# Architectural Review Board

## Staff Report (ID # 11193)

**Summary Title:** 1310 Bryant, 1235 and 1263 Emerson: Castilleja First ARB

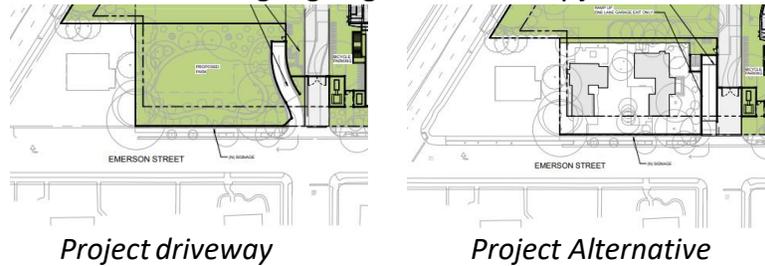
- The *Project's* garage exit driveway would be curvilinear leading to the street frontage,
- The *Project Alternative's* straight garage exit driveway just across from Melville Avenue.

The ARB's comments on the visibility/screening of vehicular egress gate and ramps for the Project and Project Alternative would be helpful to the review. The *Project's* curved driveway, fencing and landscaping are shown below in photographic simulation of the garage exit viewed from Melville. The simulation shows the brick wall, landscaping, and curve in the ramp would help the garage exit blend into the Castilleja campus, preventing visibility of the garage exit gate.

*a. Tree Removals and Views*

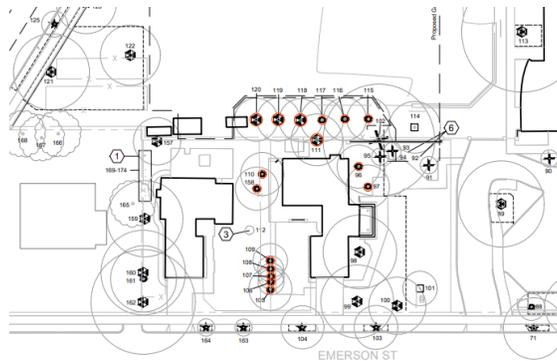
The ARB's purview includes review of proposed landscaping and views of the site from off-site vantage points, and this includes existing trees on the site. The Project removes 31 trees and relocates 34 trees. The Project would change the views of the site from each frontage, with changes in tree locations and canopy. However, following Project construction, the landscaping within and around the perimeter of the site would be similar to the existing landscaping on the project site. Analysis is found in Final EIR Master Response 8, which notes the visual impacts due to tree removal and construction impacts were evaluated in Impact 5-1 in Draft EIR Chapter 5, Aesthetics. The Project Alternative involves 21 fewer tree removals.

### Castilleja Alternative Proposal "Castilleja Gate" July 2020

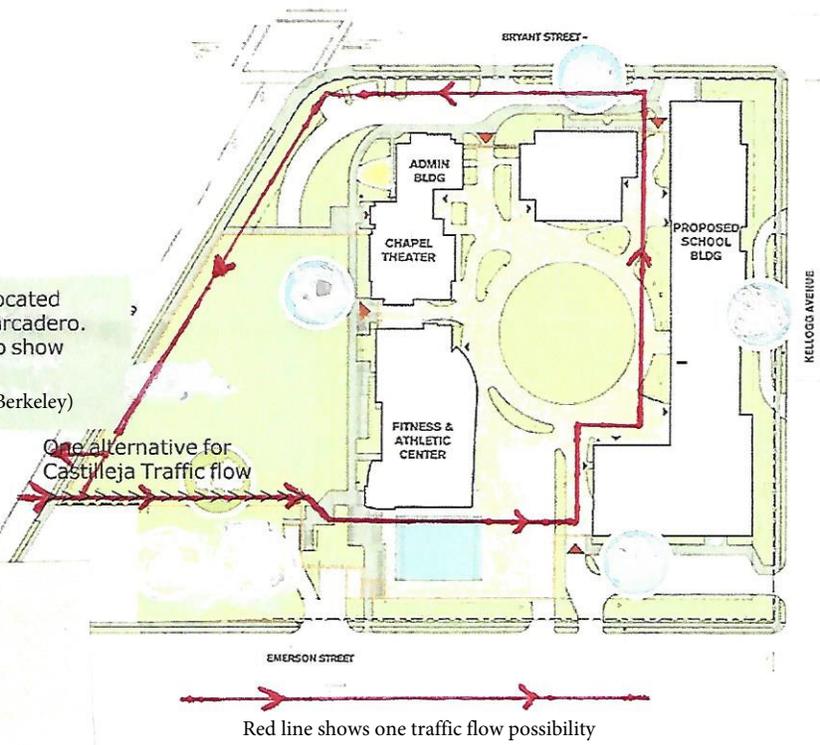
The following alternative plan we propose has the ultimate goal of mitigating the extreme traffic environmental impacts stated in the FEIR and thereby benefiting the City, Castilleja, the neighborhood and bicycle riders. The plan is to create a “Castilleja Educational Village” with traffic flow into and out of the Village from Embarcadero.

The attached diagram illustrates one possible surface traffic flow diagram for the Castilleja Educational Village, based on the current Castilleja plan drawings. Other flow patterns are possible. Thank you for your time and attention in considering this alternative.
